PROPOSED CHANGE NO. SC-01-002R1

Date: July 24, 2025
File: 9.1.7.4.2_SC-01_PC
Project No.: 2215C
Project: TA Blakelock HS Reno - Phase 3
Subcontract: SC-01 General

Description: Elevator 2 (drama area)

CONTEMPLATED CHANGE NOTICE No. S1

2215-C	A104
--------	------

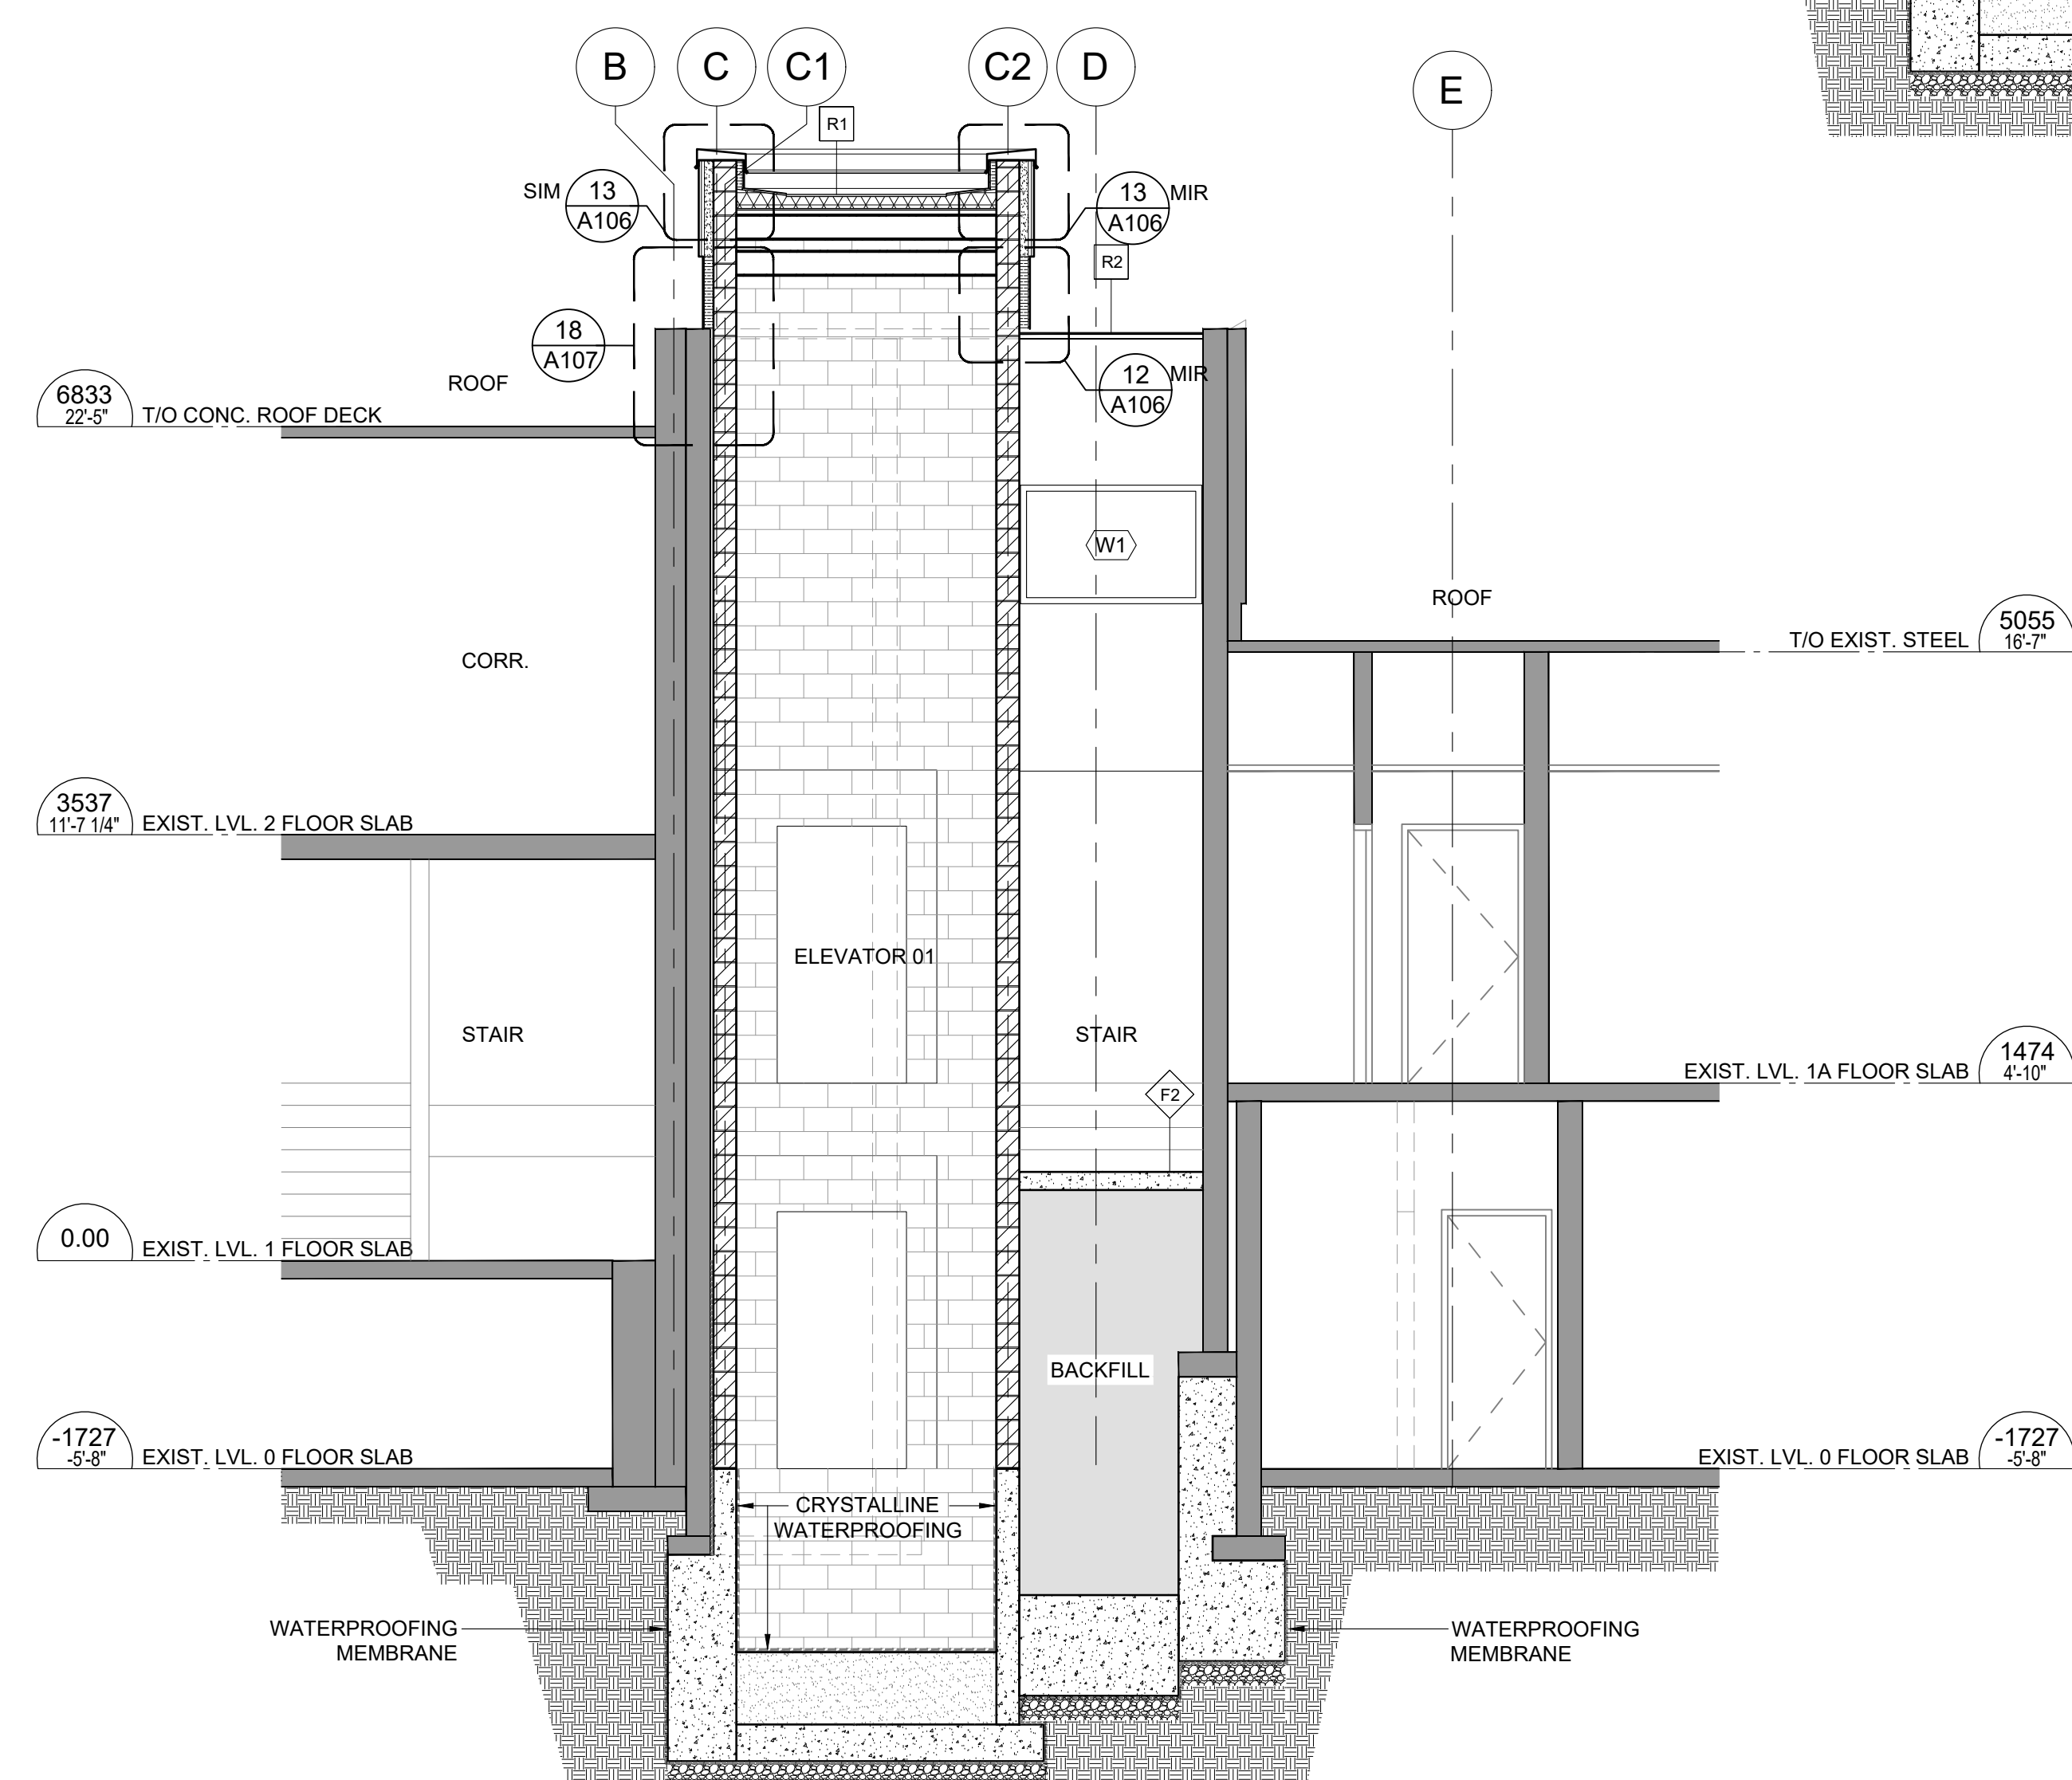
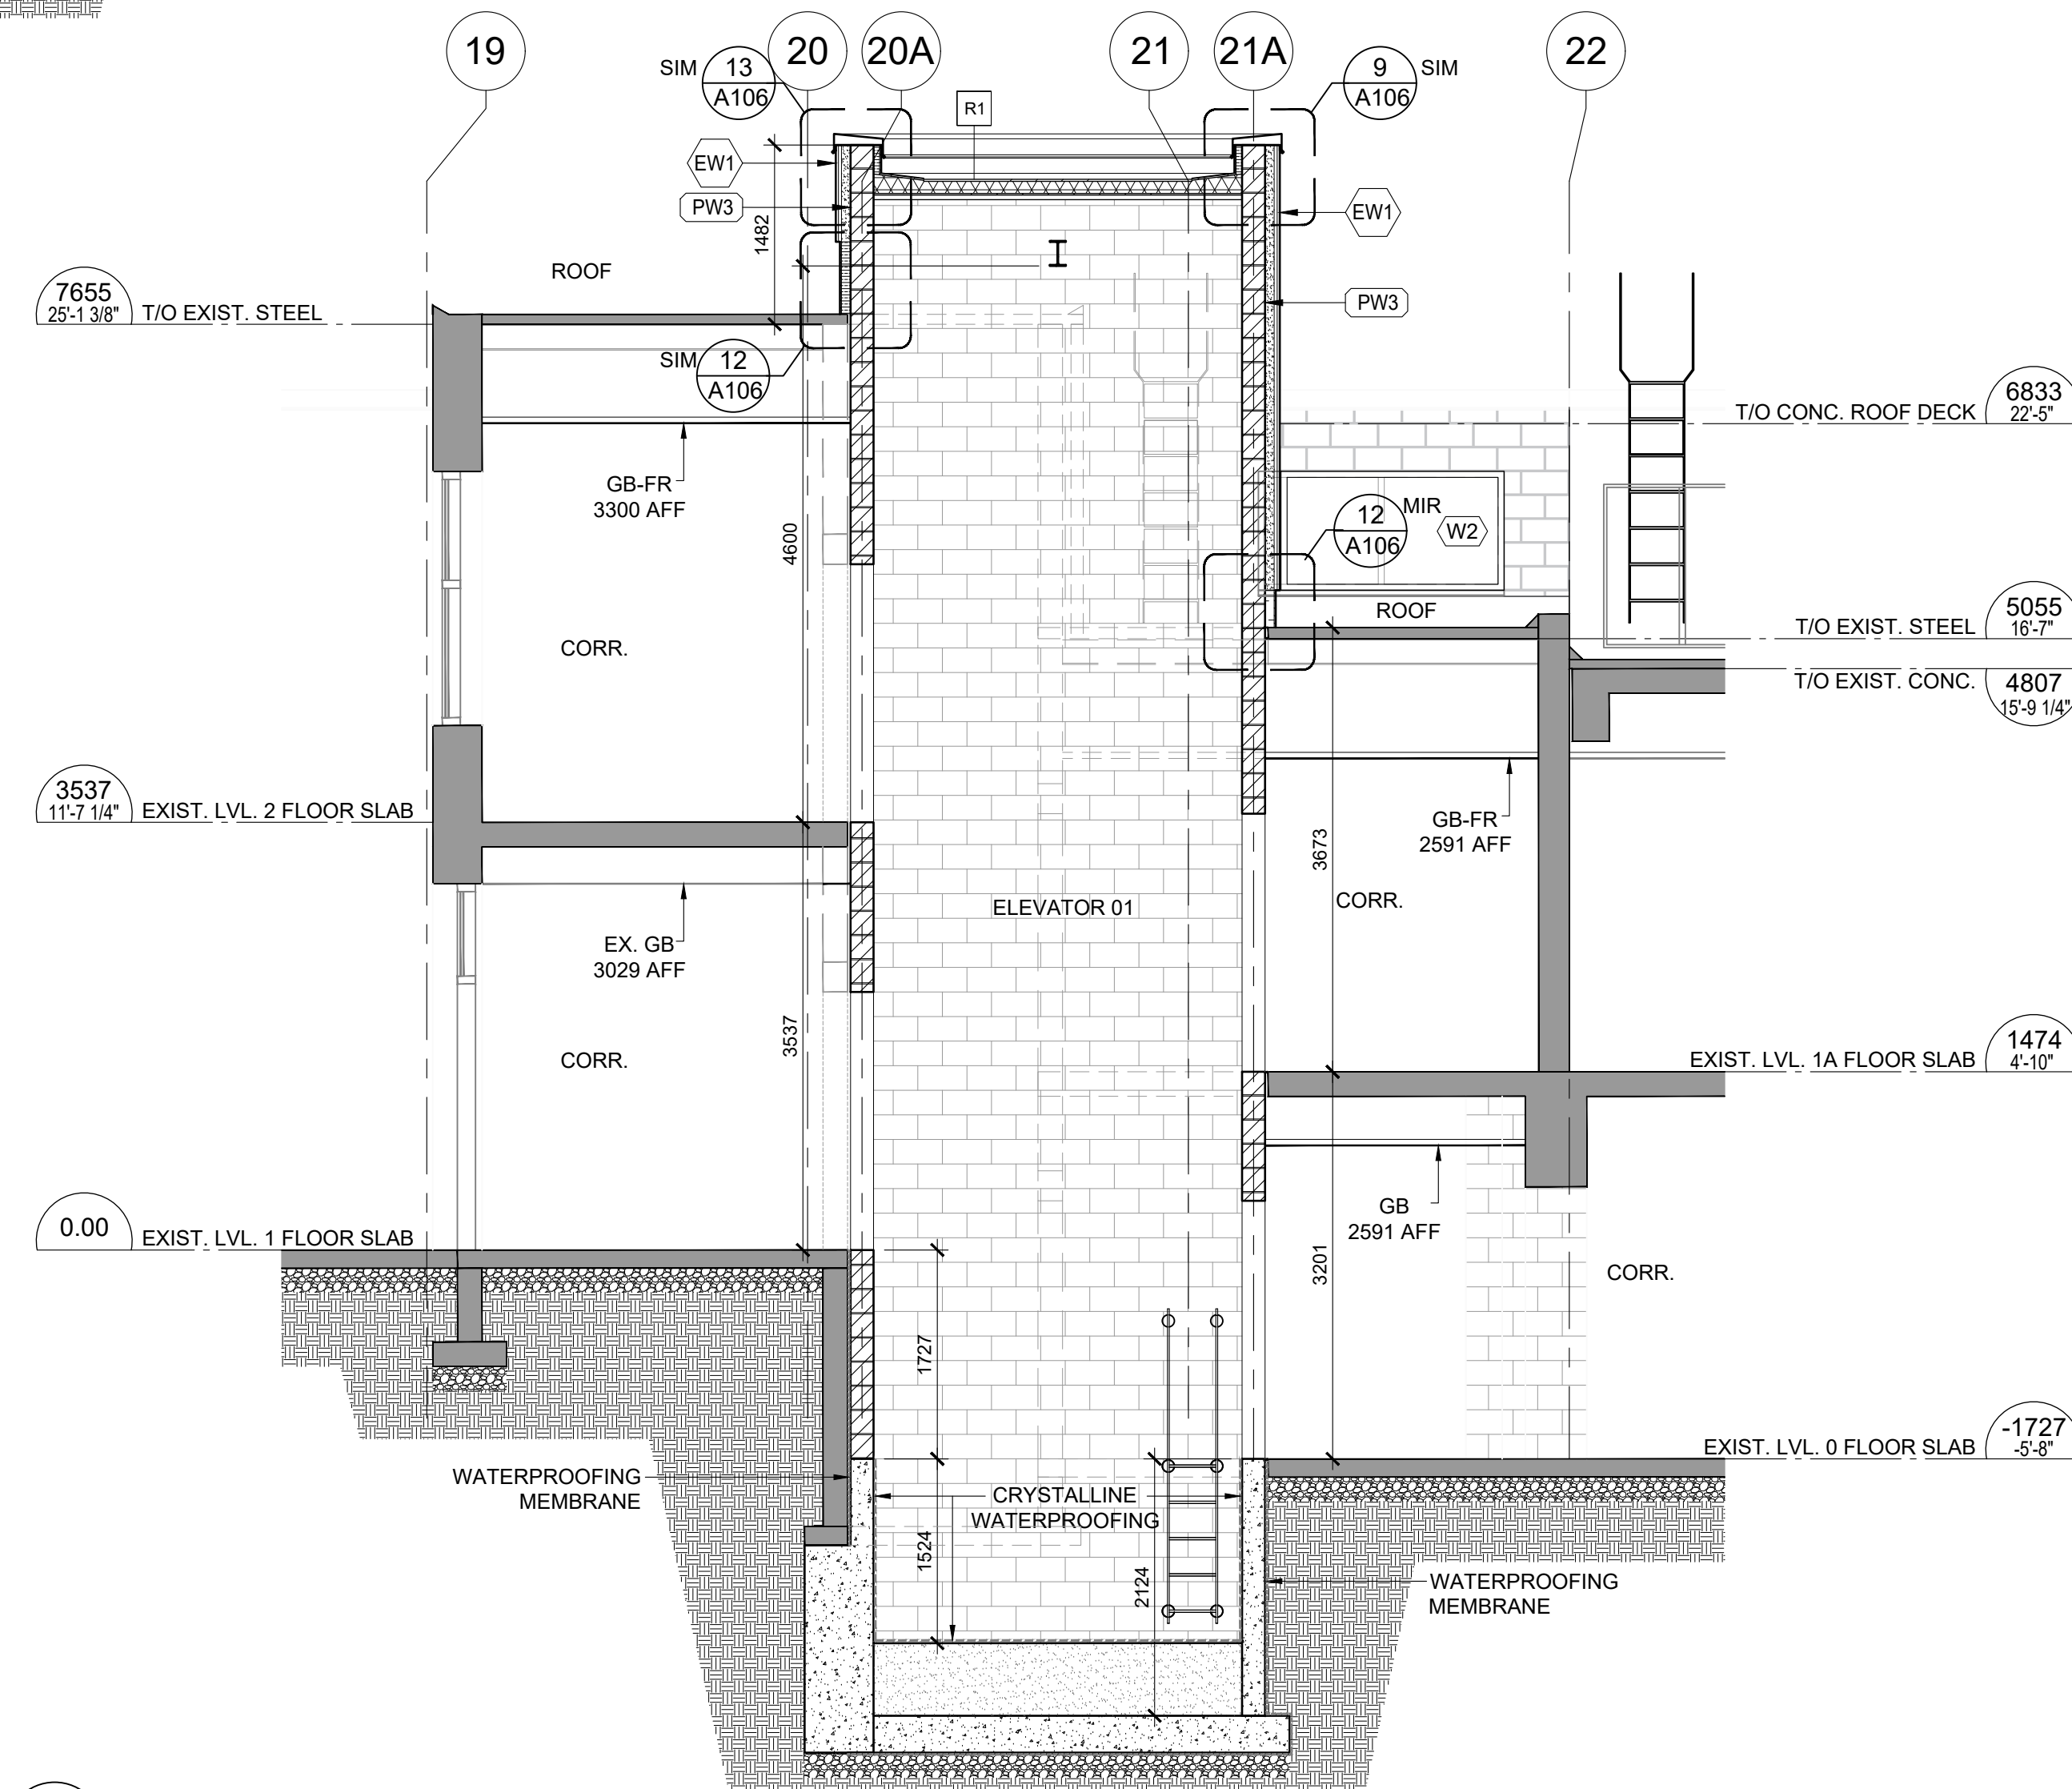
1. Refer to attached updated A100 floor plans and A104 updated sections.
2. Refer to Structural CONTEMPLATED CHANGE NOTICE No. S1 item 1 for requirements.
3. Mechanical CCN to follow adjusting sump pit location and corresponding drainage and piping to it. Electrical CCN to follow confirm power and control until location for sump pit.
4. Refer namely to sump pit relocation, deletion of underpinning along West side of Drama Room (Refer to Structural CCN for scope).
5. Provide 36x 36 ACUDOR FT-8050 concrete floor door, single leaf, 1" recessed to receive flooring. Provide cut sheet. Note this ACUDOR is intended to clear the 24" dia sump pit including sump pit flange. Confirm with vendor. Set sump pit lid just at u/s of lid opening. Provide cut sheet of ACUDOR. Run sump pit venting and discharge line within adjacent 190mm CMU wall.
